GE Energy

MFN 04-136

Subject: **ESBWR Design Changes Since Design Description**

ESBWR Design Changes Since Design Description

Figure 1. ESBWR Core Schematic

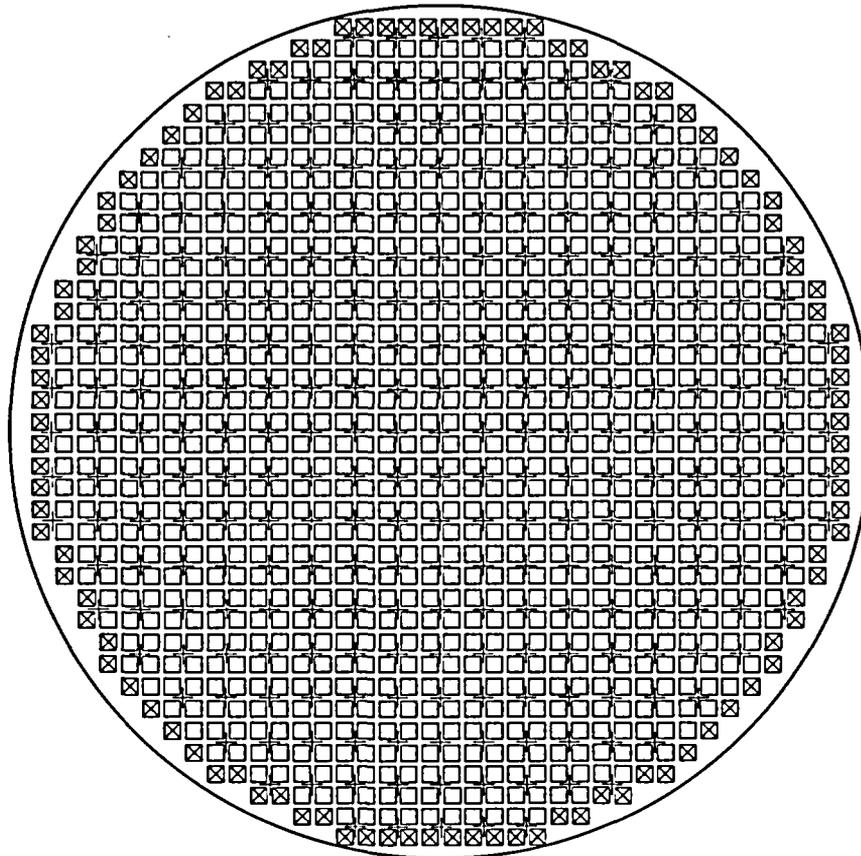
The F Lattice, as described in Section 2.2 of Reference 1, contains a triangular-pitch control rod pattern that controls twelve fuel assemblies using one large control rod and controls each corner of the array by an adjacent control rod. This arrangement will be replaced by the standard BWR square-pitch control blade pattern with one control blade that controls each four-bundle cell. For ESBWR the core lattice type is now described as an N Lattice. The total number of control rod drives increases from 121 to 269 with this lattice change and the core size increase described above in Section 2.1. All reactor internal components that were modified to accommodate the F Lattice, such as the Control Rod Guide Tube, Fuel Support, Core Plate and Top Guide will revert back to the standard BWR designs. The new core and control blade configuration is illustrated in Figure 1.

Figure 2. ESBWR Safety System Configuration (not to scale)

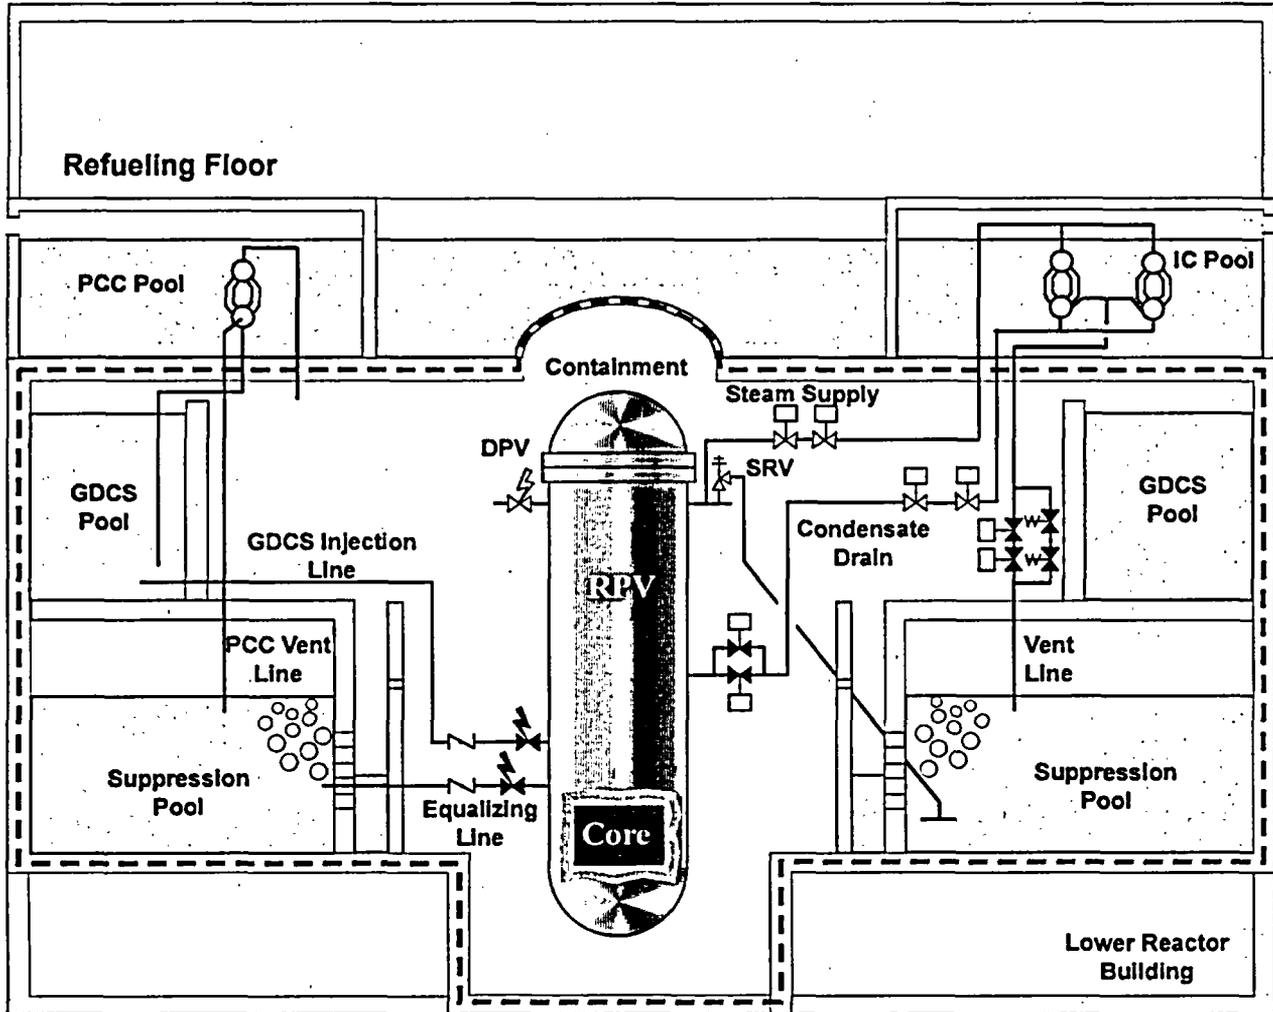
The GDCS pool airspace connections have been moved from the wetwell back to the drywell. Along with this the connecting vent between the wetwell airspace and the GDCS pool airspace has been eliminated (Figure 2). This configuration is the same as the arrangement in the Simplified Boiling Water Reactor (SBWR) design, which makes the configuration the same as in the integral systems test programs – PANDA M and GIRAFFE – used for qualification of the TRACG code. Containment volumes were adjusted along with this change to ensure the resulting wetwell-to-drywell volume ratio retains most of the benefit in reduced containment pressure that was gained when this GDCS airspace volume was originally moved from the drywell to the wetwell. While the previous configuration provided additional efficiency in the containment pressure performance, it resulted in several complicating design issues. This change primarily affects Sections 1.4.2 and 4.1 of Reference 1.
